# Spokane Design Review Board

Wednesday, December 11, 2019

5:50 – 7:00	<ol style="list-style-type: none"><li>1. Riverfront Park – North Bank Playground – M&amp;O Facility<ul style="list-style-type: none"><li>• Staff Report..... 5-10 m</li><li>• Applicant Presentation..... 10-15 m</li><li>• Reserved for Public Comment (3 m ea.)..... 20 m</li><li>• Board Discussion and Advisory Action(s)..... 30 m</li></ul></li></ol>	Taylor Berberich
-------------	---	------------------

Figure 2. Adjusted Project Scope

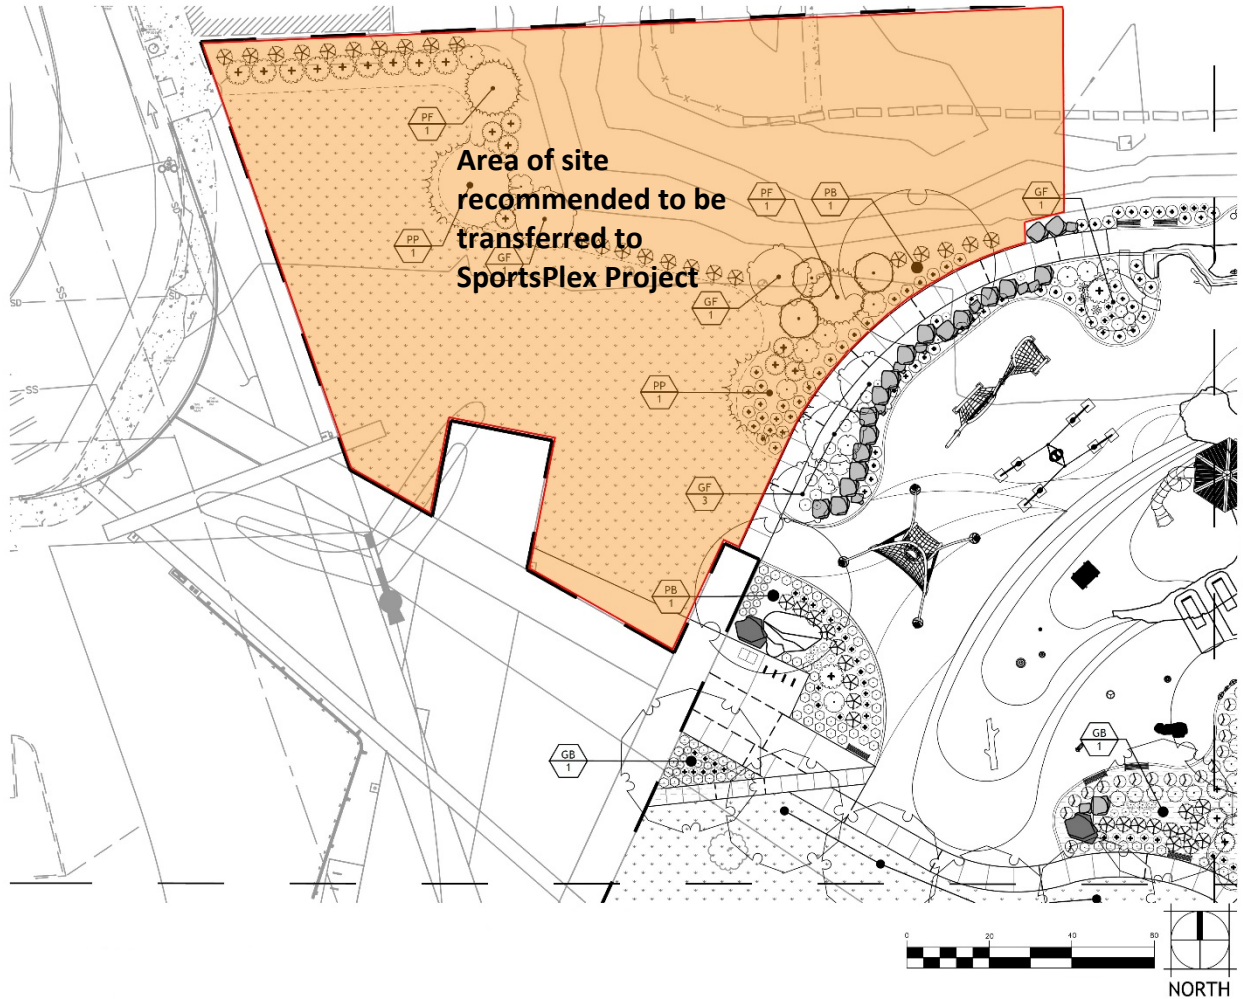
The SportsPlex design team has developed a concept worth reviewing, though the North Bank Playground submission still shows the area used for this proposed route treated with fill and landscaping. Staff wonders if a solution would be more easily achievable if the scope of work (and any funds associated with the proposed landscaping) were transferred to the SportsPlex project. The proposed scope transfer would permit the two separate projects (with separate construction schedules) to follow their own construction schedules without conflict of trades. Based on comments from the applicant, the Playground project does not have any funds to implement any treatment in this area (even the landscaping shown in the Planting Plan) so a transfer of scope to the SportsPlex Project would be even less complicated as funds would not need to be co-mingled. See Figure 2, below.

Figure 2. Additional Site Furnishings

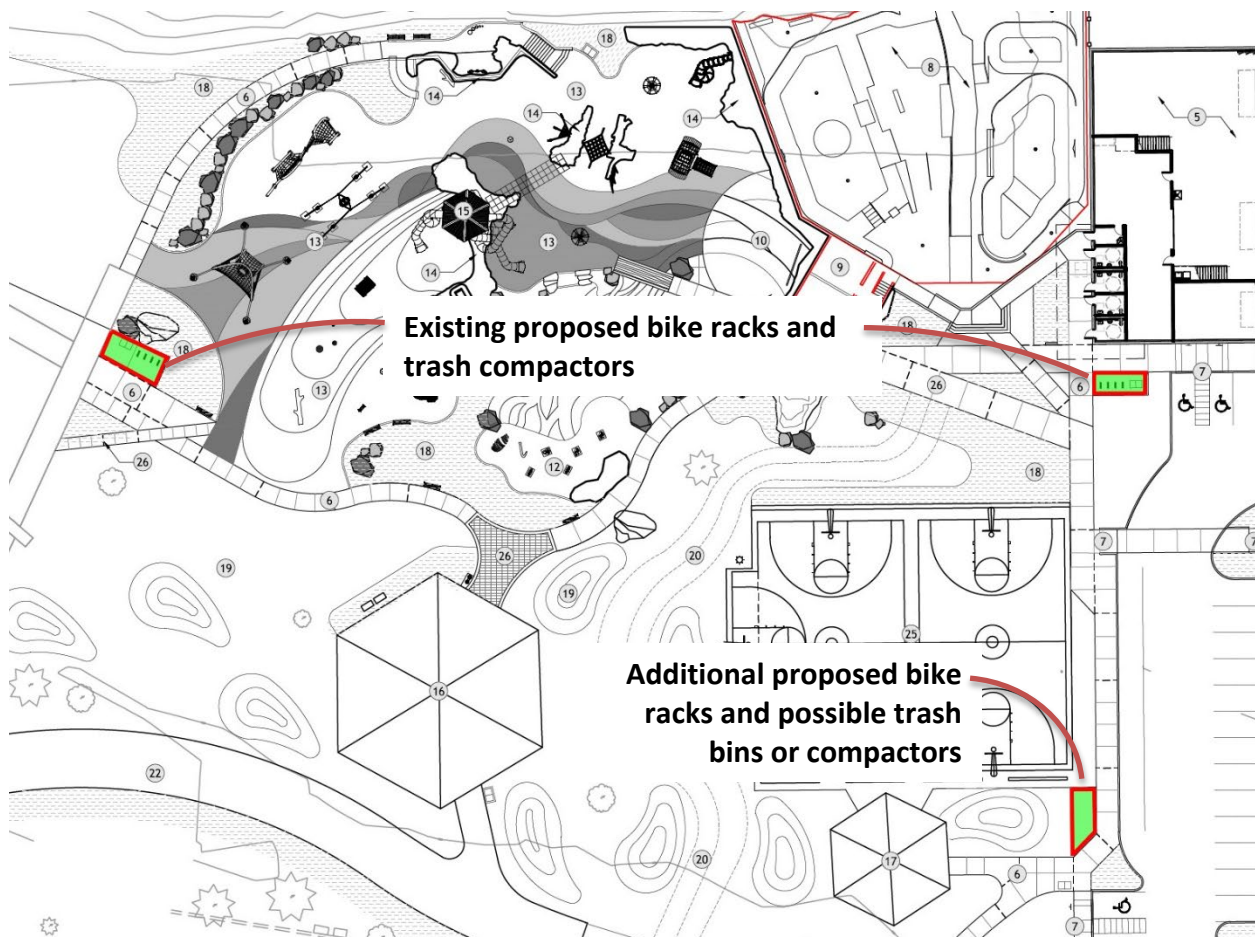
Would the inclusion of an additional bike rack cluster near the historic Park Shelter (adjacent to the new basketball courts) be warranted (with or without trash bins or compactors)? See Figure 2, below.
